**World Forum for Harmonization of Vehicle Regulations****Working Party on General Safety Provisions****125th session**

**Awareness of the Proximity of Vulnerable Road Users:  
UN Regulation No. 46 (Devices for indirect vision)****Proposal for Supplement 1 to the 05 Series of Amendments to  
UN Regulation No. 46 (Devices for indirect vision)****Submitted by the expert from the International Organization of Motor  
Vehicle Manufacturers \***

Figure 9  
**Figure 9.1**  
 Class VI field of vision for side-steered vehicle

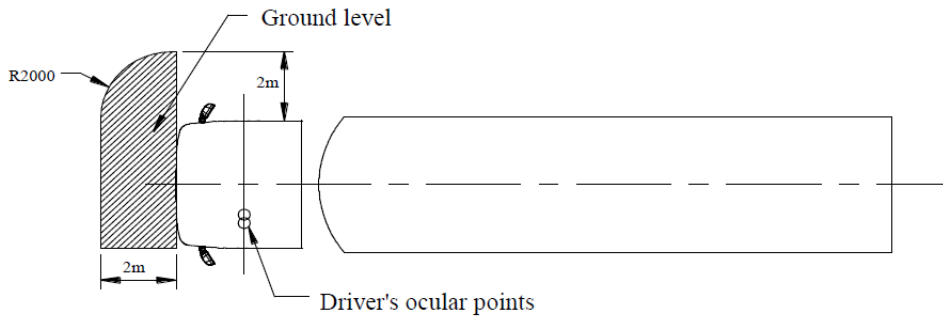
"15.2.4.6.1. The field of vision shall be such that the driver can see at least a flat horizontal portion of the road, which is **for side-steered vehicles** bounded by:

- (a) A transverse vertical plane through the outermost point of the front of the vehicle;
- (b) A transverse vertical plane 2,000 mm in front of the plane defined in (a);
- (c) A longitudinal vertical plane parallel to the longitudinal vertical median plane going through the outermost side of the vehicle at the driver's side; ~~and~~
- (d) A longitudinal vertical plane parallel to the longitudinal vertical median plane 2,000 mm outside the outermost side of the vehicle opposite to the driver's side.; **and**
- (e) ~~The~~ **the** front of this field of vision opposite to the driver's side may be rounded off with a radius of 2,000 mm (see Figure ~~9~~ **9.1**).

Figure 9.1., amend to read:

**Figure 9.2**  
 Class VI field of vision for centre-steered vehicle

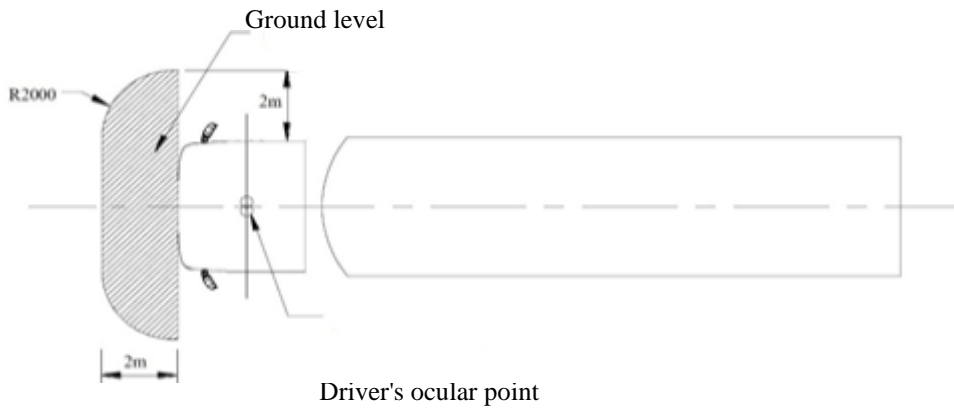
**The field of vision shall be such that the driver can see at least a flat horizontal portion of the road, which is for centre-steered vehicles bounded by:**

- (f) **A transverse vertical plane through the outermost point of the front of the vehicle;**
- (g) **A transverse vertical plane 2,000 mm in front of the plane defined in (a);**
- (h) **A longitudinal vertical plane parallel to the longitudinal vertical median plane 2,000 mm outside the outermost side of both sides of the vehicle; and**
- (i) **The front of this field of vision on both sides may be rounded off with a radius of 2,000 mm (see Figure 9.2).**

Insert a new figure 9.2., to read:
